# Access Compliance Report

## Public Rights-of-Way

### (Curb Ramps)

Intersection ID: 16419	Main Street: LANTANA_AV	Cross Street: N_SHARON_AMITY_RD	Location: NW
ADA ID: F49ADEF47FFF	Ramp Type: PerpDiag	Initial Pass/Fail: Fail	Overall Compliance: No
Severity Score: 10			
Codes/Mitigation Info/Possible Solution		Field Measurements/Component Compliance

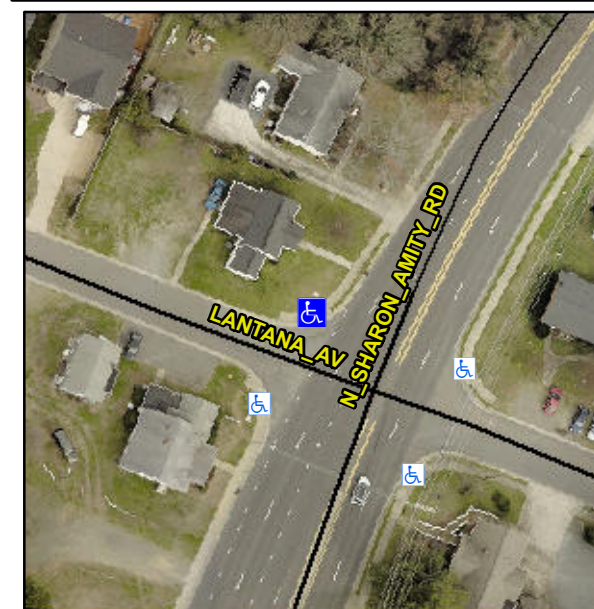
**Not Found, R304.5.1, R304.5.3**

Compliance	Description	Data	Compliance	Description	Data
N/A	Ramp Length (in)	73.0	Yes	Ramp Slope (%)	5.2
No	Ramp Width (in)	41.0	No	Ramp XSlope (%)	2.3
N/A	Flare Type LT	N/A	N/A	Flare Type RT	N/A
N/A	Flare Slope LT (%)	N/A	N/A	Flare Slope RT (%)	N/A
N/A	Flare Traversable LT?	N/A	N/A	Flare Traversable RT?	N/A
N/A	Landing Length (in)	N/A	N/A	DWS Provided?	N/A
N/A	Landing Width (in)	N/A	N/A	DWS Contrast?	N/A
N/A	Landing Slope (%)	N/A	N/A	DWS Length (in)	N/A
N/A	Landing X Slope (%)	N/A	N/A	DWS Full Width?	N/A
N/A	Landing Curb? (Y/N)	N/A	N/A	DWS Offset (in)	N/A
N/A	Shared Landing?	N/A			
N/A	Gutter Ponding?	N/A	N/A	Gutter Slope (%)	N/A
N/A	Gutter Lip Ht (in)	N/A	N/A	Gutter X Slope (%)	N/A
N/A	Painted X Walk1?	No	N/A	Painted X Walk2?	No
	X Walk 1 Direction	To SW		X Walk 2 Direction	To SE
N/A	X Walk 1 Width (in)	N/A	N/A	X Walk 2 Width (in)	N/A
	X Walk 1 Slope (%)	2.8		X Walk 2 Slope (%)	5.3
	X Walk 1 X Slope (%)	4.8		X Walk 2 X Slope (%)	0.3

**Remove & Replace Curb Ramp With Two New Directional Ramps or Equivalent.**
